Attention: Daniel Shao
Company: Woolworths NZ
Date: 21 February 2024
From: Mark Brown
Message Ref: Proposed Woolworths Development Madras St - CCC S92 Request Landscape Response
Project No: BM240948B Woolworths Madras St

Christchurch City Council has requested further information and provided feedback related to landscape matters in their s92 request. Our responses are detailed in the following memorandum.

Cross Section: Typical East Boundary Setback Arrangement Cross Section

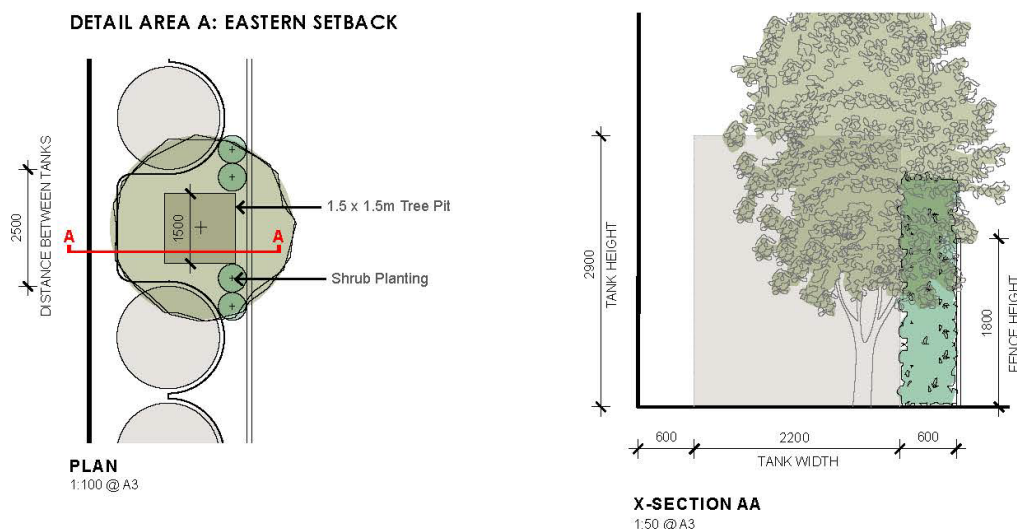
S92 / RFI 8. Please provide sketches or cross sections that show how the proposed hedges and tree planting are to be arranged against the east and southern building elevations. No details are provided.

In addition to the rendered image of the southern boundary setback area shown on page 13 of the Landscape Design Report originally submitted with the resource consent application, detail plans and cross sections for the eastern and southern setback are illustrated below and appended to the attached updated Landscape Concept Design Report.

The **eastern boundary setback** incorporates a 2.2m diameter, 2.9m high tank, specimen tree located in a nominal 1.5m x 1.5m wide tree pit within a nominal 3.3m to 3.4m wide setback width. Continuous hedge planting is not proposed adjacent to the proposed detention tanks located in the east boundary setback.

Cross Section: Typical South Boundary Setback Arrangement Cross Section and Detail Plan

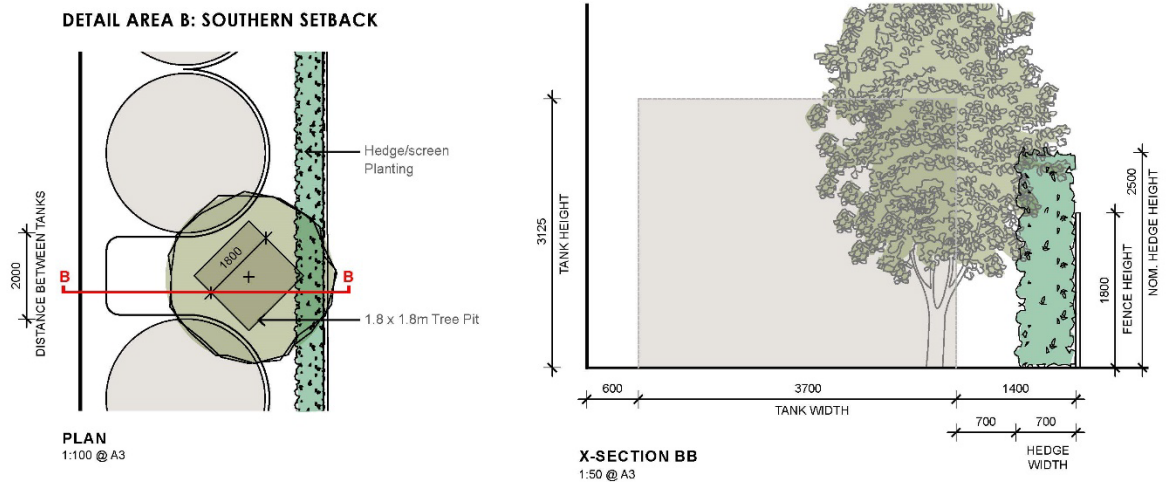
S92 / RFI 9. Please explain how are the trees and the water tanks to be co-located successfully. No details are provided.

The **southern boundary setback** incorporates a 3.66m diameter, 3.125m high tank, specimen tree located in a nominal 2m x 2m wide tree pit and 2.5m high hedge within a nominal 5.7m to 5.8m wide setback width.

Please refer to detail plans included in response to RFI 8 above, and appended to the updated Landscape Concept Design Report. These indicate how trees will be located with sufficient tree pit space between the groups of tanks within the eastern and southern setbacks (1.8m x 1.8m pits on the southern boundary, 1.5m x 1.5m pits on the eastern boundary). Pipe runs between tanks will need to be incorporated within the 'inside' half of the respective setback widths. While access is tight, there is space for maintenance access to either side of the tanks within the southern and eastern setback areas

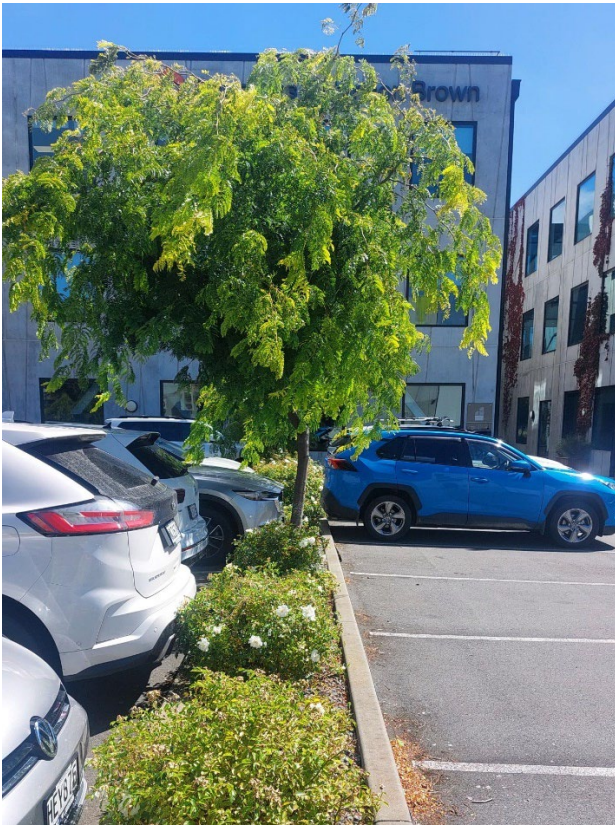
Initial Feedback 1. For successful tree establishment, and tree longevity, all landscape strips should be 1.5m minimum width (internal dimensions) to ensure minimum tree pit soil volumes are achieved (see below for guidance). In particular, the landscape strips in the car park area are not dimensioned but seem to be about 1.0m wide. The landscape strips on the southern boundary (western end nearest to road frontage) are only 1.1m wide. These will not be wide enough to support successful tree establishment.

The landscape areas within the car park area are nominally 1.0m wide, along with the 1.1m wide landscape strip on the southern boundary.

Please note we have allowed for revised tree species that fit the 'small' categorisation in the table above, in response to **Initial Feedback 3** below.

Plan Update: *Liriodendron tulipifera* in the northwest corner

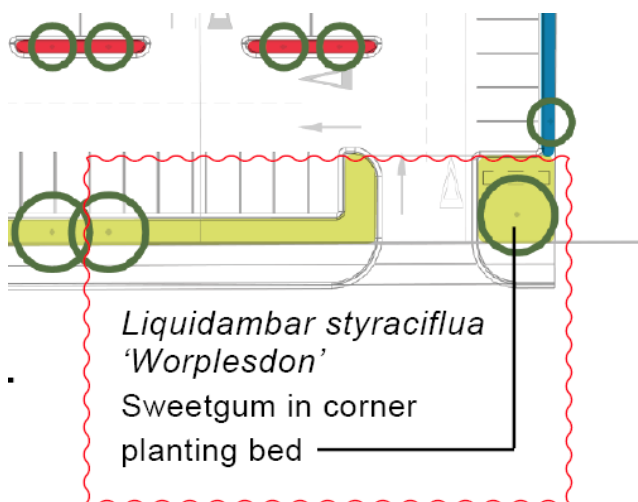
Initial Feedback 2. The two corners on Madras Street have largish landscape beds – a good opportunity to add some larger trees, such as the *Liriodendron tulipifera* (an upright variety of this tree has been proposed for the small park).

Yes, large to medium size trees are anticipated in these locations, as shown on plan – we have updated the Planting Concept Plan and Planting Palette Species List (refer to images below) to clarify the inclusion of a *Liriodendron tulipifera* in the northwest corner. Please note that the southwest corner of the site adjacent to Madras Street is proposed as the location for the development’s water supply pump and backflow preventer, which practically limits the size of the tree to a medium sized specimen. A *Liquidambar styraciflua* ‘Worplesdon’ is indicated in this location.

Plant Palette Species List Update: Revised Tree Species

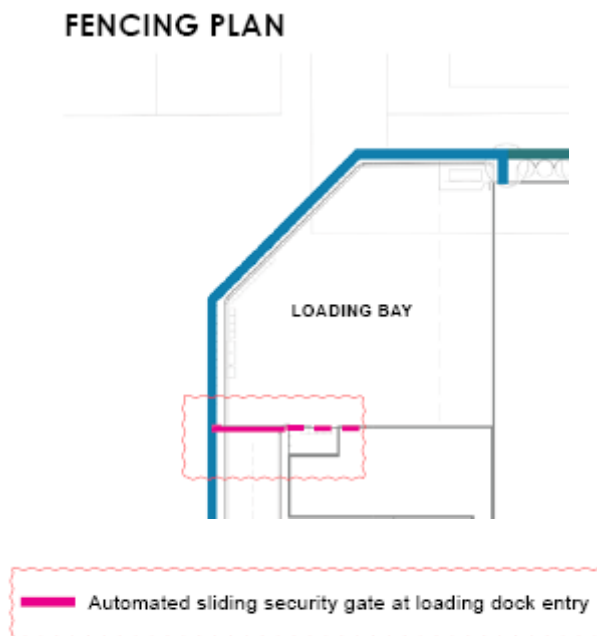
Initial Feedback 3. Tree species selection – some tree species selections such as lancewoods, Plagianthus, Hoheria and Kowhai will do ok, however the Hinau and the Red Beech will really struggle in these growing conditions and should be replaced with a more suitable tree.

Hinau and Red Beech species have been replaced with smaller *Pseudopanax crassifolius* Lancewood and *Hoheria angustifolia* Houhere / Narrow-Leaved Lacebark within the Area F Car Park species list.

In the Area A East Boundary Planting – Building Setback, Area B South Boundary Planting – Building Setback species lists, Hinau have been replaced with *Magnolia grandiflora* 'Blanchard' Evergreen Magnolia.

Lastly, in the Area E North Boundary Planting – Car Park Setback species list Hinau and Red Beech species and been replaced with *Magnolia grandiflora* 'Blanchard' Evergreen Magnolia and *Plagianthus Regius* Manata / Ribbonwood
